STATE OF MAINE  
DEPARTMENT OF HUMAN SERVICES  
AUGUSTA, MAINE 04333

SUBJECT: Denial of New System Variance Request, Allen property, Burns Road,  
Augusta

# NEW SYSTEM VARIANCE REQUEST

# SUBSURFACE WASTEWATER DISPOSAL SYSTEM APPLICATION

## SUBSURFACE WASTEWATER DISPOSAL PLAN

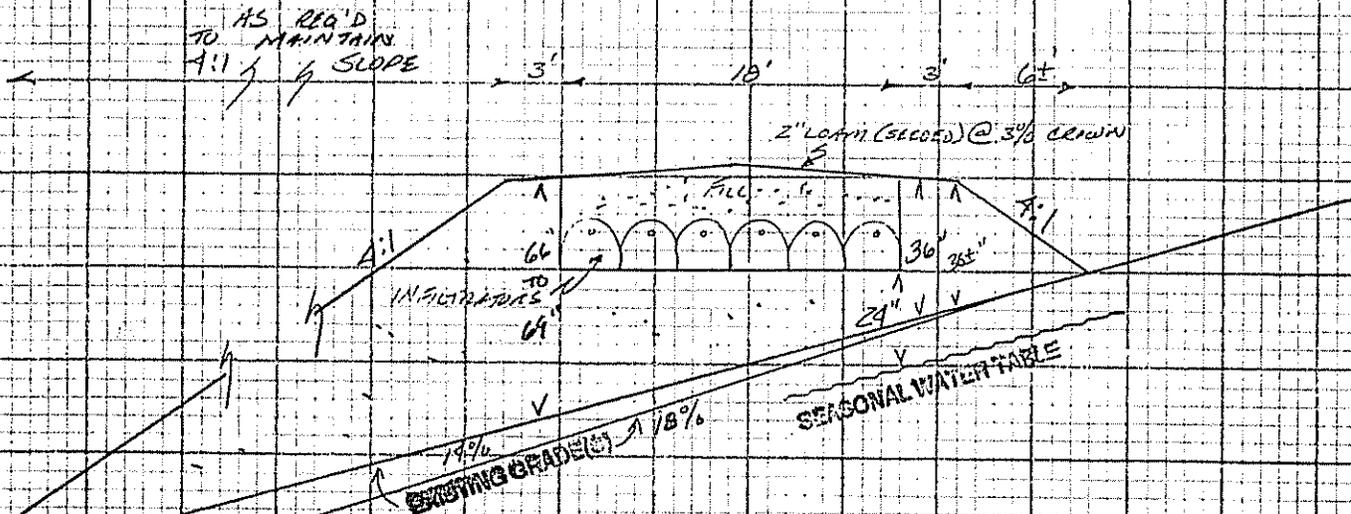
Our review of your Application for a New System Variance indicates that a new disposal system cannot be installed on your property in full compliance with the Rules. You have requested the following:

To allow a disposal system to be installed on soils that do not meet the minimum criteria. Specifically, the seasonal high groundwater table is located 12 inches below grade.

On October 31, 1980 a variance to the Rules was granted to Mr. Pamphile Dostie. The variance approval was based upon the points that were awarded for the property size. Your proposal is to subdivide the lot which would in effect, nullify the original variance approval.

The Division does not approve of the application and prohibits Gary Fuller, the Local Plumbing Inspector, from issuing a permit to install a subsurface wastewater disposal system. Our denial is for the following reason(s):

The 3.3 acre lot cannot be subdivided and will be limited to one-single family residence.
